Access Compliance Report Public Rights-of-Way (RR Crossings)

Intersection ID: 7131	Main Street: N_TRYON_ST	Location: N/A
ADA ID: 6E78E7031CB1	Overall Compliance: No	Severity Score: 0.0
Codes/Mitigation Info/Possible Solution		Field Measurements/Component Compliance

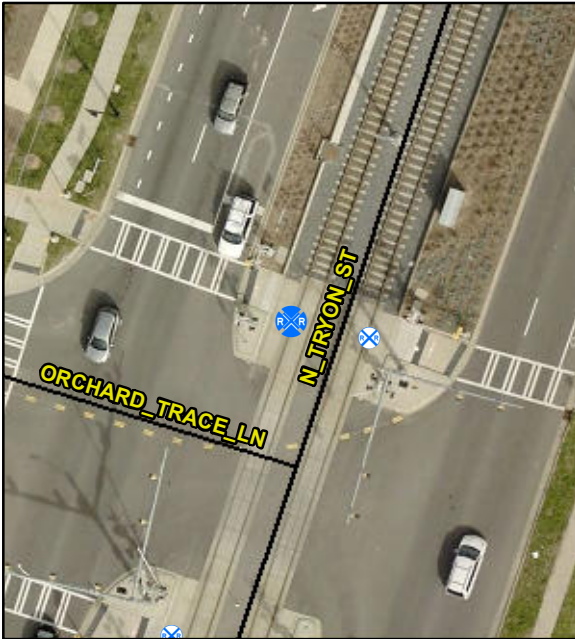
R302.7.4

Compliance	Description	Data
Yes	DWS Provided?	Yes
Yes	DWS Contrast?	Yes
Yes	DWS Width (in)	Yes
Yes	DWS Length (in)	24.0
Yes	DWS Offset (in)	149.0
Yes	Pedestrian Gate?	Yes
N/A	DWS Outside Gate?	Yes
N/A	Rail Type?	LightRail
No	Flangeway Gap (in)	2.5
Yes	Sidewalk Width (in)	120.0

**Remove & Replace Walking Surface
Adjacent to Rail.**
